December 17, 2010

**Re: Florida Power Corporation
d/b/a Progress Energy Florida, Inc. (PEF)
Crystal River Fossil Plants
Petition to Modify Site Certification PA 77-09
Ash Storage Vertical Expansion and Other Misc. Projects (Mod P)
Response To FDEP's Request for Additional Information
Dated October 11, 2010**

Exhibit 1: Finite-difference grid used for the model, superimposed on the base map. The computational grid (in the horizontal direction) is 10 ft by 10 ft in the general vicinity of the IWW ponds.

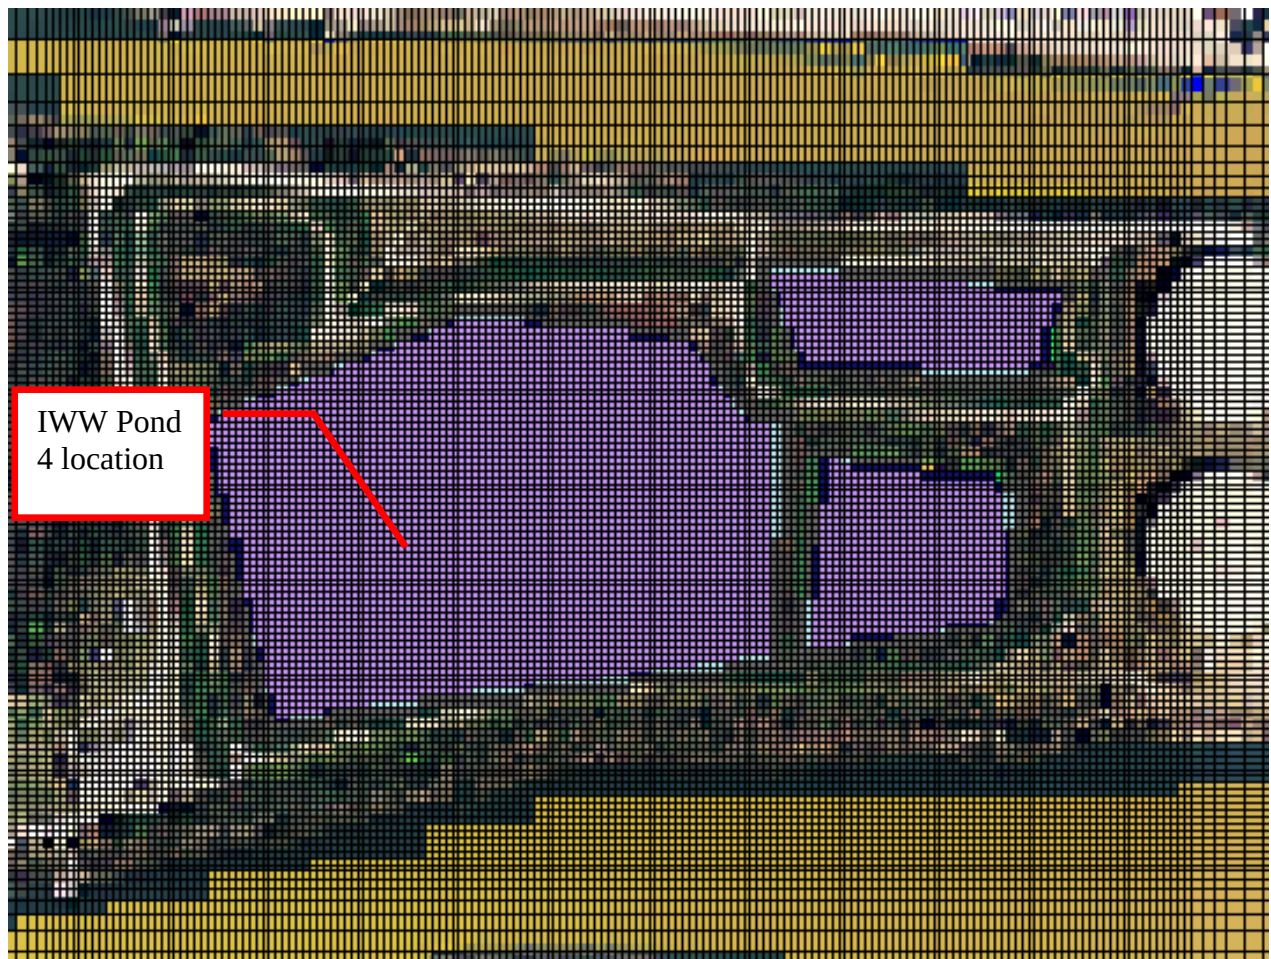
FDEP Comment No. 1. Please provide a MODFLOW simulation cell grid map with a greater focus on the pond area. Report Figure 6 scale is simply too small to provide the level of detail needed in evaluating the model grid.

Geosyntec Response to Comment No. 1. Exhibit 1 consists of the requested figure showing grid discretization near the pond area. The horizontal grid spacing is 10 ft by 10 ft in the pond area. The maximum grid spacing within the entire domain is 100 ft by 100 ft.
